# North Hertfordshire District Council

## Building Conservation comments

**File Ref:** 23/00407/FP & 23/00408/LBC

**Address:** Node Court, Drivers End Lane, Codicote, Hitchin, Hertfordshire SG4 8TR

**The Dairy:**

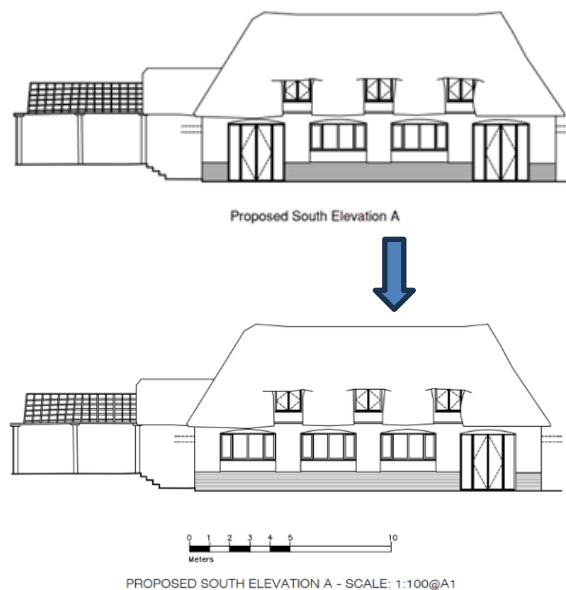
The roof lights have been changed to eyebrow dormers. This change has been updated on all plans elevations and rendered elevations.

Note: Whilst I note the eyebrow dormer approach on the drawings in the revised 'Design and Access Statement and Planning Statement' prepared by Briffa Phillips Architects and dated December 2024, I have not seen the full series of amended drawings outside of this document.
